CLIENT A2 DOMINION GROUP				DWG. TITLE REVISED LANDSCAPE PLAN			
PURPOSE OF ISSUE LANDSCAPE IMPROVEMENTS PROPOSAL							
SITE BICESTER, ECO VILLAGE, SCHOOL							
DRG BY PW	CHECKED	AUTH'D	SCALE 1:100@A3	Rev. date 25/02/2020	DWG NO. 1.4	REV.

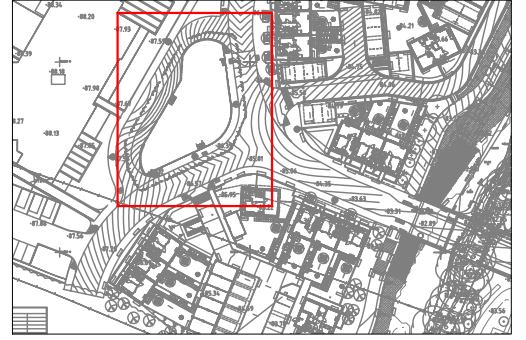
Need to confirm the alignment and depth of the sewer, and any easements/distance required from tree planting.
